SECTION 4.55(1A) MODIFICATION APPLICATION, SSD-7382 UTS CENTRAL PROJECT, BROADWAY PRECINCT

This application has been prepared by Ethos Urban on behalf of the University of Technology Sydney (UTS), pursuant to section 4.55(1A) of the *Environmental Planning and Assessment Act 1979* (EP&A Act) to modify State Significant Development Consent SSD-7382 relating to the extension of Building 1 and the redevelopment of Building 2 (CB02) (otherwise known as UTS Central) at the Broadway Precinct of UTS (the site).

Figure 1 Proposed Substation Ventilation Shaft and Stairs

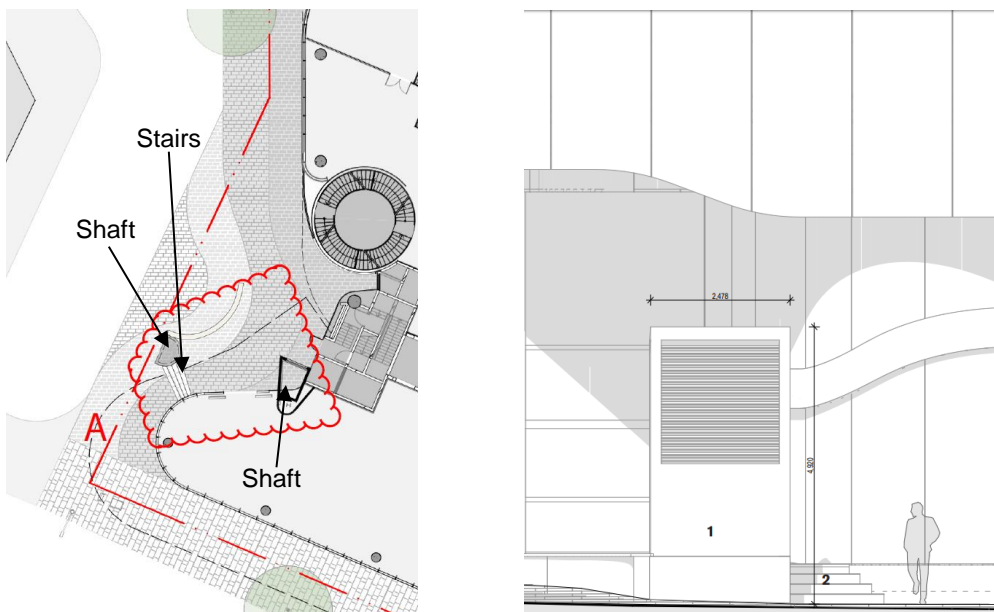
In accordance with Ausgrid requirements, two ventilation shafts with louvres are required to provide inflow ventilation and outflow exhaust to the approved electrical substation on Level 2. The proposed ventilation shafts are to be located within the site boundary along Jones Street near to the edge of the UTS Central building and in proximity to Broadway.

The proposed ventilation shafts are a critical item to the functioning of the substation and meet the design specifications as required by Ausgrid. The shaft furthest from the building facade is 4.9m in height and 2.5m in width. A louvre panel is integrated in one side of the shaft. The second shaft is proposed to be in the façade fronting Jones Street and comprises a concrete upstand and lid that fits within the recess of the facade. The ventilation shafts are proposed to be rendered and painted to match the Alumni Green façade. They will connect to existing services and infrastructure. Adequate clearance is provided between the underside of the louvres and the public thoroughfare.

A new set of steps is also proposed between the freestanding shaft and the UTS Central Building. Four steps are required to address the local ground level conditions.

Refer to **Figure 1** for the location and view of the proposed substation ventilation shaft and steps.

Figure 2 Amendments to Alumni Green Façade, demonstrating extension of 'sandstone' finish element

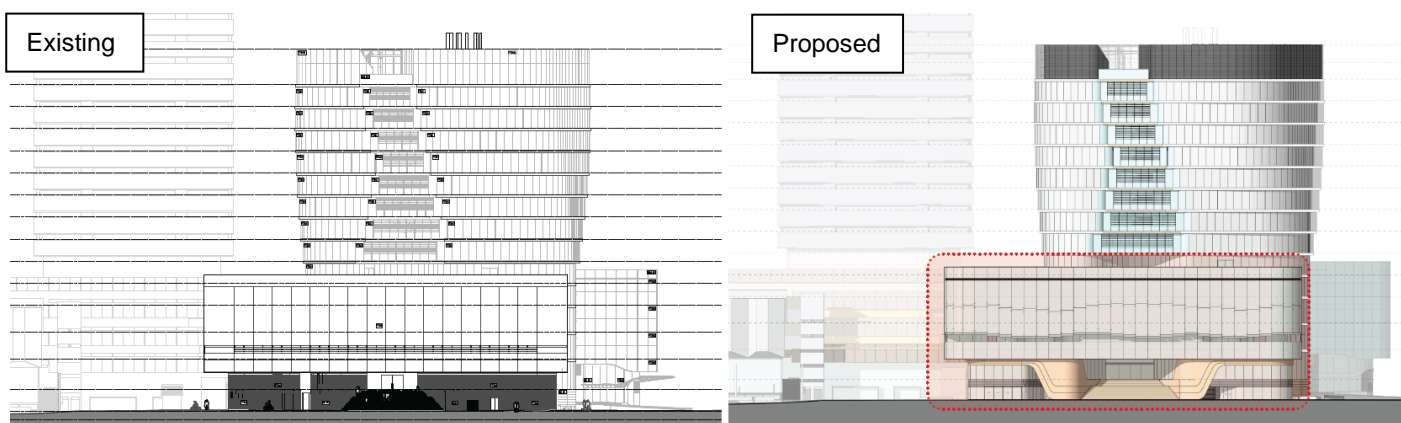
Under this modification, the relationship between the solid and transparent materials on the façade has changed at levels 3 and 4. The painted render ‘sandstone’ finish element has been extended to run from either side of the stairs then tapering to a narrow strip at high level running to the edge of the façade wrapping around the corners. This also affects a small part of Jones Street where the façade wraps around the corner of the building.

The Reading Room façade is also proposed to be modified. Previously, the horizontal glass joints running across the façade had been in a continuous alignment. The glass joints are proposed to be modified to be staggered across the length of the façade, making the openings much larger in some areas. Refer to **Figure 2** below.
